IEEE802.3bt
LLDP adhoc

Meeting #3: Rev 001, Tuesday June 27, 2017

LLDP concept review as agreed in D2.5 – Updated per the current text Proposal for a change marked in RED. Agreed concept marked in BLUE.

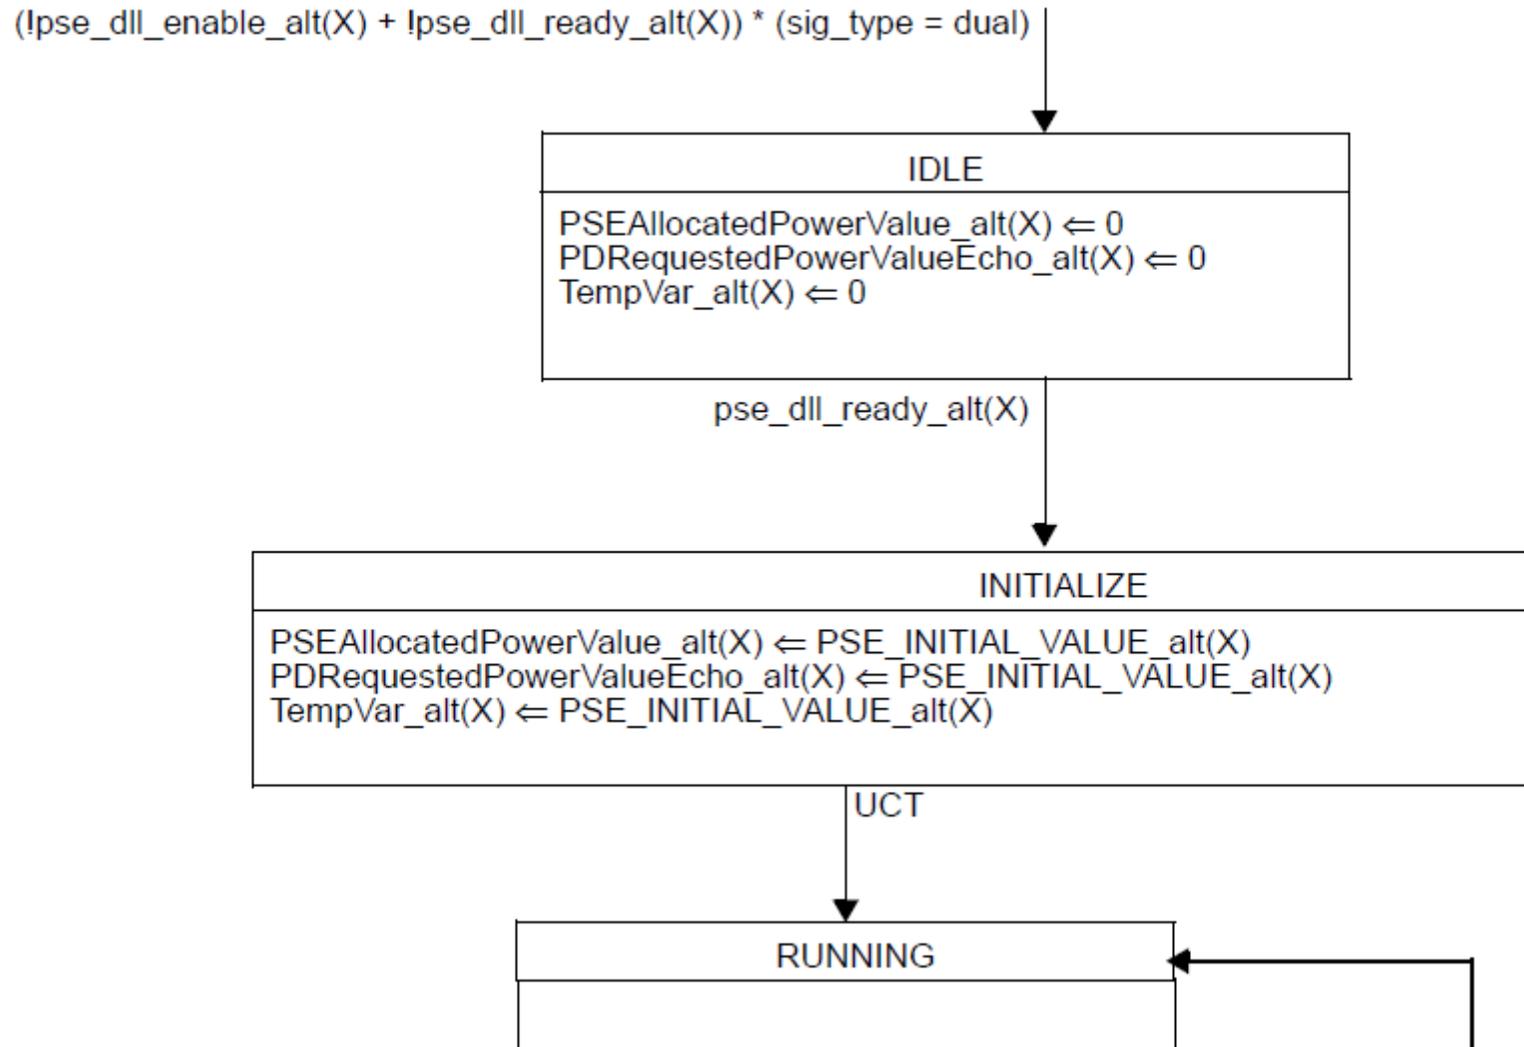
#	PSE Type	Operating over	Connected to a PD	TLV field			
				pse_allocated_power	pd_requested_power	pse_allocated_power_Alt(X)	pd_req_power_mode(X)
				Y	Y	X (A or B or both)	X (A or B or both)
1	3/4	4-pairs	SS	1-999	1-999	0	0
2	3/4	2-pairs	SS	1-999	1-999	0	0
3	3/4	4-pairs	DS	1-999, Y=A+B (**) Lennart+Yair: Y=0.	1-999, Y=A+B (**) Lennart+Yair : Y=0.	1-499	1-499, Use A and B. Y=A+B.
4	3/4	2-pairs	DS	1-499, Y=A+B (**) Yair: Y=Alt(X) where X is the active pair instead of Y=A+B. Lennart: A and B=0. Yair: will not work. We need Y=Alt(X) per the simulations. PSE Y need to work with PD Y. If A=B=0 how will we know that Y is correct and is sync with A or B? David Tremblay : In the transition for 4-pair to 2-pair what should be the minimum value that goes to Y. Suggested is to go to the value of the last allocated value of A or B. (to be added to the description and not to the state machine)	1-499, Y=A+B (**) Yair+Lennart: Y=mode(X) where X is the active pair instead of Y=A+B.	1-499. Y=Alt (X), X is the active pairs. Yair: To add: (*) if Alt(X) is inactive, set to value 0.	1-499. Use A and B. (*) if mode(X) is inactive, set to value 0. Lennart+Yair: To resolve #297, delete (*). Y=mode(X), X is the active mode.

5	1/2	2-pairs	DS	1-499, May Y=A+B Similar to line 4 with the open question if Type 1 and 2 can use the new TLV fields.	1-499, Y=A+B (**) Similar to line 4.	1-499. Similar to line 4.	1-499. Use A and B. (*) if mode(X) is inactive, set to value 0. Similar to line 4.

The above Table covers all use cases (Type 3/4 connected to Single-signature or dual-signature PD over 4-pairs or 2-pairs and switching between 4-pairs to 2-pairs and back to 4-pairs.

Comment #297 D2.4 (Page 75 line 12 in D2.5) - Figure 145-43

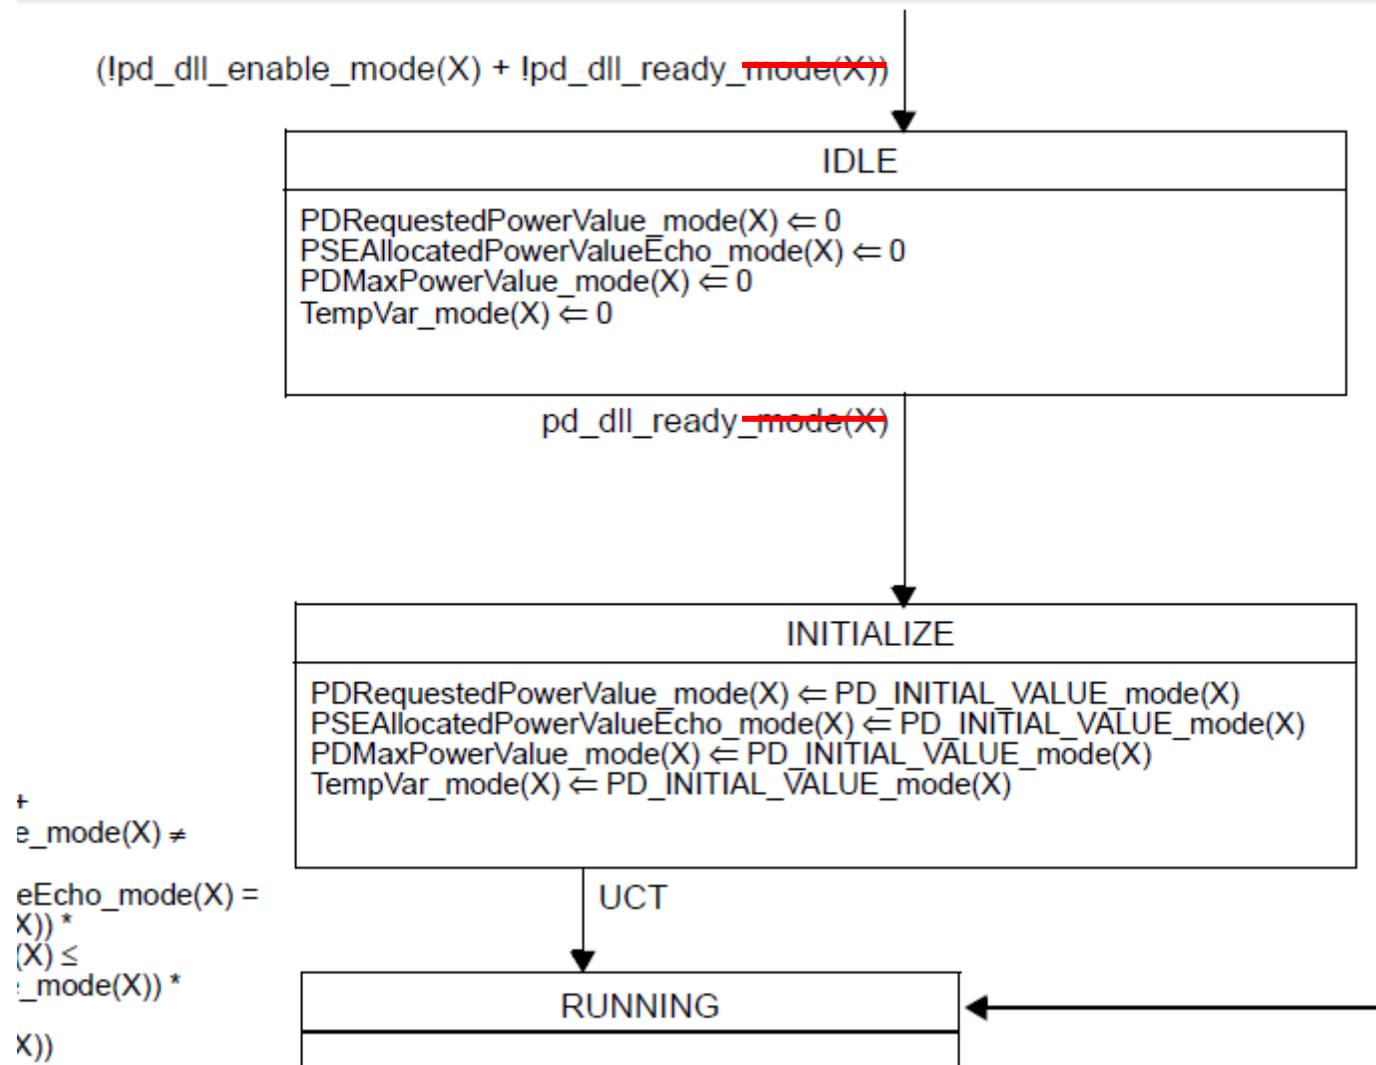
Comment #297 D2.4 (Page 75 line 12 in D2.5) - Figure 145-44
 Proposal for a change marked in RED. Group is OK.

- Comment #297 D2.4 (D2.5 Page 78 line 46)
"If Mode (X) is non-active while the other mode is active, the inactive PD requested power value Mode (X) field value shall be set to 0."
 - What is this trying to do ? The PD may wish to ask for power on an unpowered Mode...

Strike sentence.

- Yair it will work:
- The proposal is:
 - To change from `pd_dll_ready_mode(X)` to `pd_dll_ready` in the PD state machine.
 - To change “if this mode/Alt is inactive, set to value 0” to “if this Alt is inactive, set to value 0” i.e. keep this requirement only to PSE.

- Group is OK.
